UNITED STATES PATENT AND TRADEMARK OFFICE

Office Action Summary

10/718,195

DETAILED ACTION

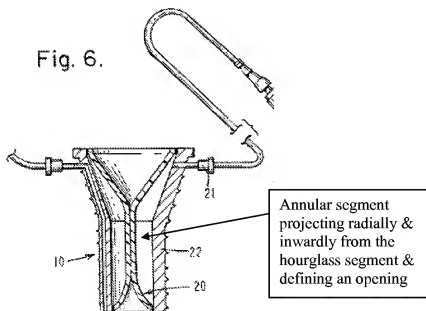
Figure 6 illustrates the sealing member (20) having a general hourglass shaped segment. Figures 5 & 6 illustrates the sealing member (20) having an annular segment and the annular segment defining an opening. See illustration below.

Regarding claim 35, in the Mollenauer et al/Stablein combination, specifically the Mollenauer's sealing member (20) dimensioned such that the opening expands such that the surfaces of the hourglass segment adjacent the annular segment resiliently contact the outer surface of the instrument (34) to form the substantial seal therewith. See Figure 8.

Regarding claim 36, in the Mollenauer et al/Stablein combination, specifically the Mollenauer's annular segment is disposed adjacent the longitudinal midpoint of the sealing member (20).
